UNDER the Resource Management Act 1991 (RMA)
AND
IN THE MATTER of an application for resource consents to extend
the Waihi Gold Mine via underground and open pit
mining methods known as Project Martha
BY **OCEANA GOLD (NEW ZEALAND) LIMITED**
Applicant

SYNOPSIS OF TECHNICAL REPORT (s42A) AND RESPONSE TO EVIDENCE BY

Geotechnical and Surface Stability

19 November 2018

Figure 1. Extract from Figure 24 of AEE Appendix P1 – shear strain at base of north wall after completion of MP4 and underground mining without backfill in old stopes below the MP4 base

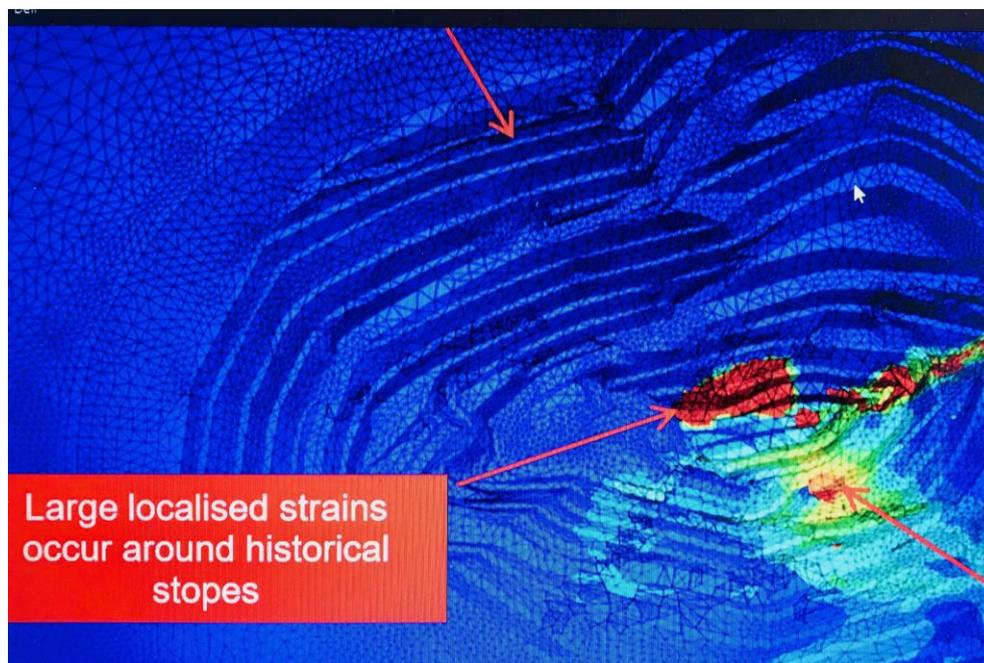
the results of the modelling of the combined MP4 – underground mining in Run 1 indicate in Figures 1 and 2.

that a zone of greater than 5% shear strain remains at the base of the completed MP4 North wall. In my opinion this level of shear strain is indicative of rockmass failure and maintaining strength in this zone is critical to minimising the risk of pit wall failure. Run 6 of the modelling included prior backfilling of unfilled historic stope voids with CAF within the zone 30m below the base of MP4 and the equivalent results to those in Figures 1 and 2 are shown in Figures 3 and 4.

without and with prior CAF placement 30m below the MP4 pit base. Based on these model findings, my opinion is that prior backfilling of historic stope voids within the zone 30m below the base of MP4 as soon as it is practical and safe to do so should be a requirement of consent condition 70 to ensure that the MP4 design remains stable and a competent buffer exists between the pit and the uppermost underground mining. While the use of CAF for that backfilling is my preferred option because of its superior stiffness and strength to limit strain and displacement, other forms of backfill including cemented rock fill (CRF) or rockfill will still be beneficial to maintaining stability of the toe and walls of the MP4 pit. I note that Mr Sullivan advocates a “wait and see” approach in his evidence and that any backfill placement in this zone should depend on pit wall behaviour and conditions exposed and be a remedial treatment rather than the pro-active one which I recommend. In my opinion this would, in all likelihood, be too late to be effective, may be too risky to undertake, and is unlikely to be completed quickly.

Figure 3. Extract from Figure 43 of AEE Appendix P1 – shear strain at base of north wall after completion of MP4 and underground mining with CAF backfill in old stopes below the MP4 base

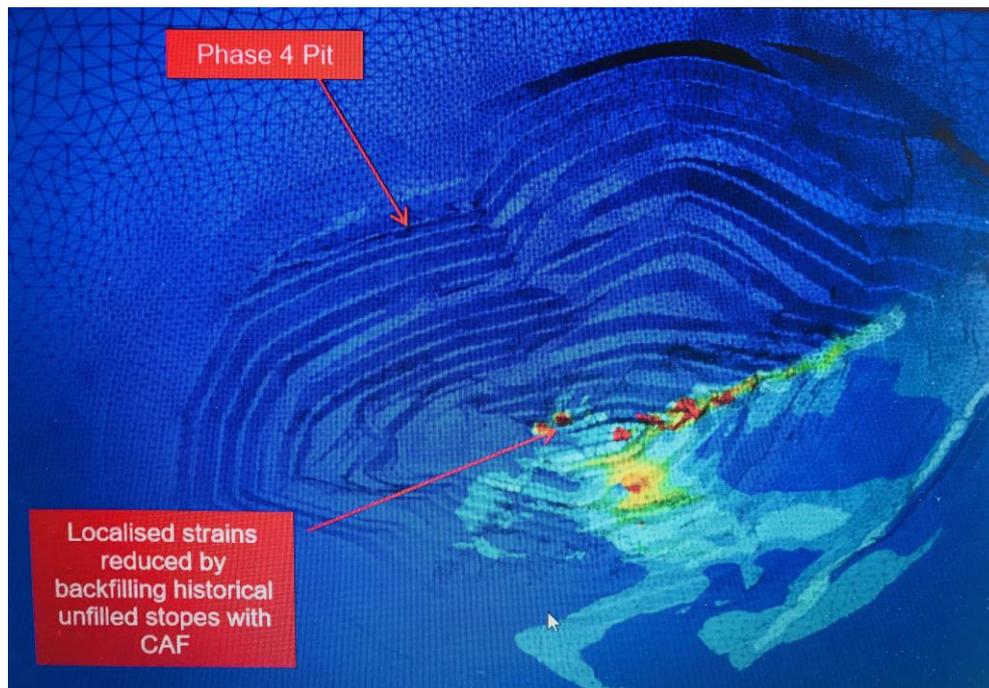
CAF backfilling has virtually eliminated the high shear strain zone leaving the rockmass at the base of the N wall relatively unaffected. A reduction in displacement from around the toe (from greater than 1m to some 30mm) can be seen by comparing results in Figures 5 and 6 for the analyses
